SERVICE BULLETIN

APPLICABILITY: 2013 MY BRZ

NUMBER: 12-145-13R

SUBJECT: Condensation in Rear Combination Lamps,
 Retaining Nut and Sealing Gasket Change

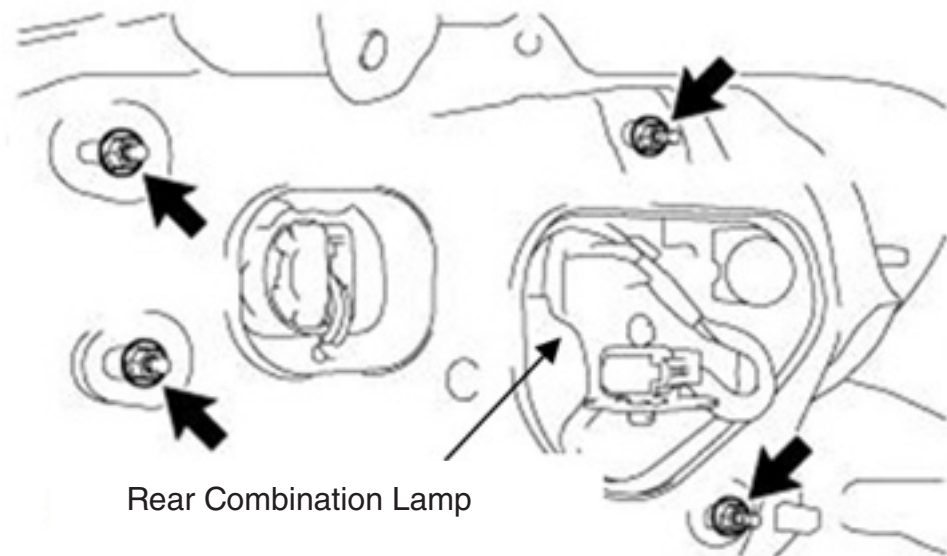
Due to a smaller diameter flange surface, the original retaining nuts may distort the rear body panel mounting and sealing surfaces for the combination lamps enough to allow moisture seepage past the seals into the combination lamps and possibly the trunk area. In addition, the thickness of the sealing gasket (packing) for the rear combination lamp has been increased from 5mm to 8mm.

Original Nut, 12mm
diameter flange surface

Revised Nut, 15mm
diameter flange surface

- The revised retaining nuts with a larger diameter flange surface were incorporated into production December 5th, 2012 starting with VIN D*605847.
- The revised combination lamp sealing gaskets were incorporated into production February 1st, 2013 starting with VIN D*607611.

Example of crack

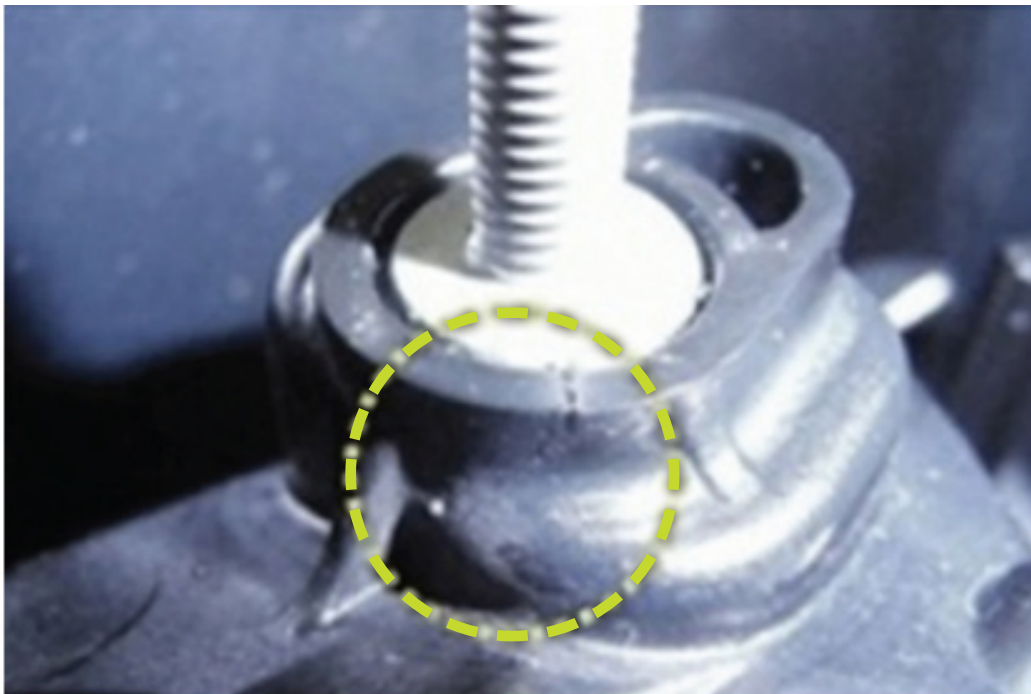
Once the combination lamps are removed, inspect their mounting stud boss areas carefully for any cracking as shown in the photo example below. Any damaged combination lamps must be replaced.

Retaining Nut Locations (4)

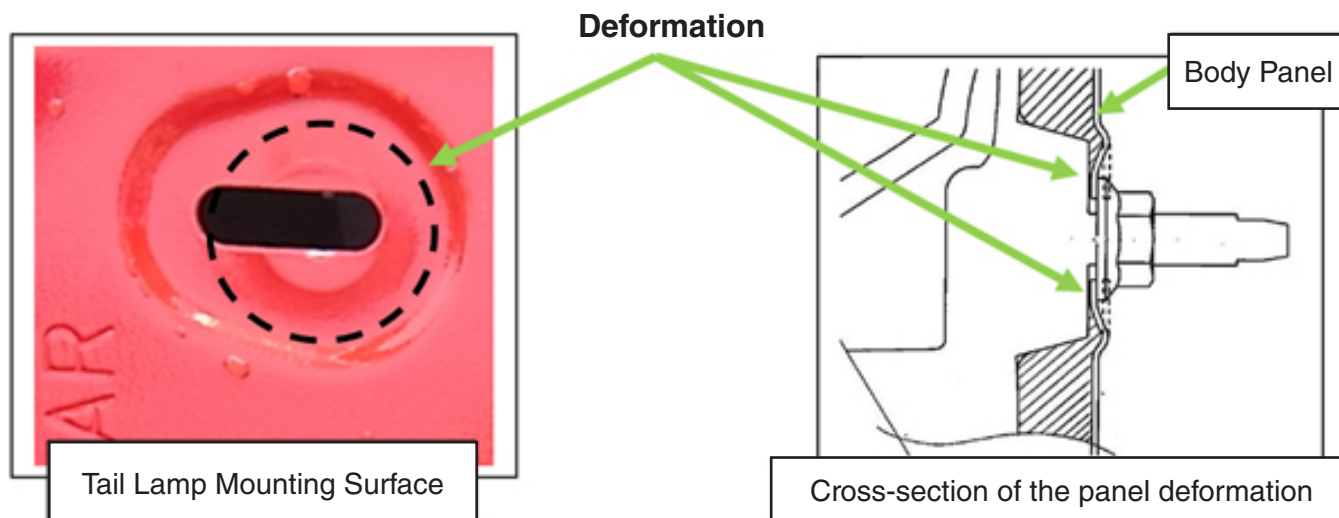
Inspect the rear body panel in the retaining nut areas for any deformation of the metal as shown in the illustrations below.

If any deformation is found, CAREFULLY straighten the affected mounting area using a small body hammer and dolly.

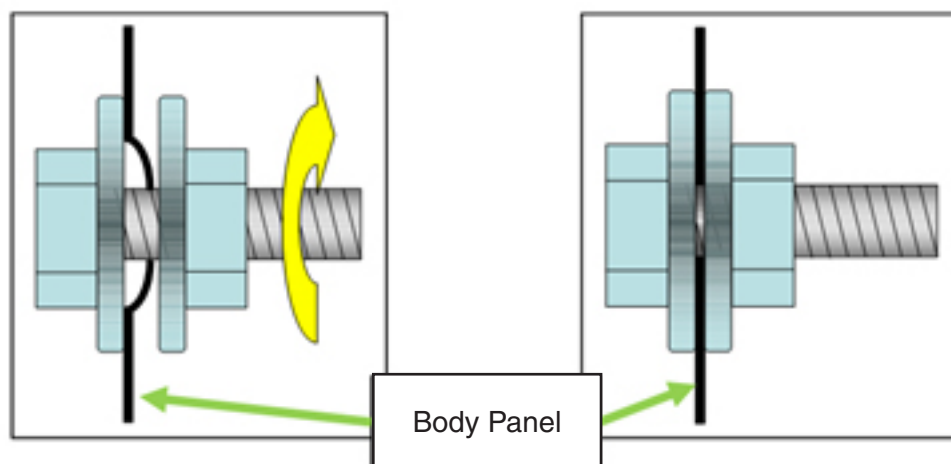
Another straightening method is to clamp the body panel using a bolt, flat washers and a nut as shown in the illustration below.

Once any deformation has been straightened, be sure to touch up any damaged paint surfaces.

L/H Sequence

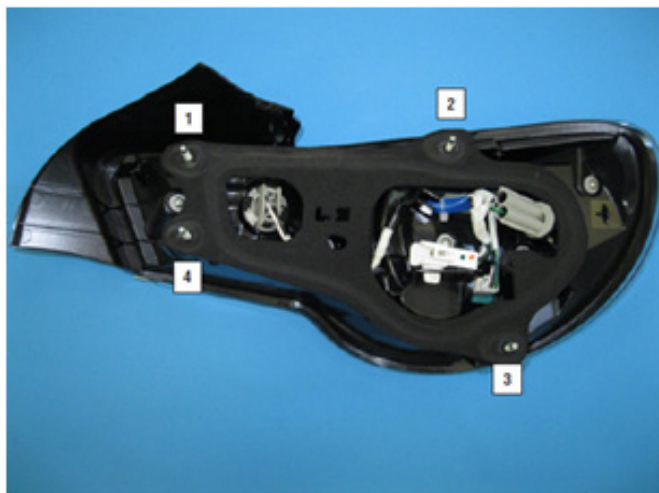
- Before reinstalling the tail combination assemblies, always install new sealing gaskets as they are one-time use items.
- The proper torque sequence must be followed as shown in the following illustrations or damage to the combination lamp assembly may result. The torque specification (unchanged) for the retaining nuts is 4.5 Nm (39 inch-pounds).
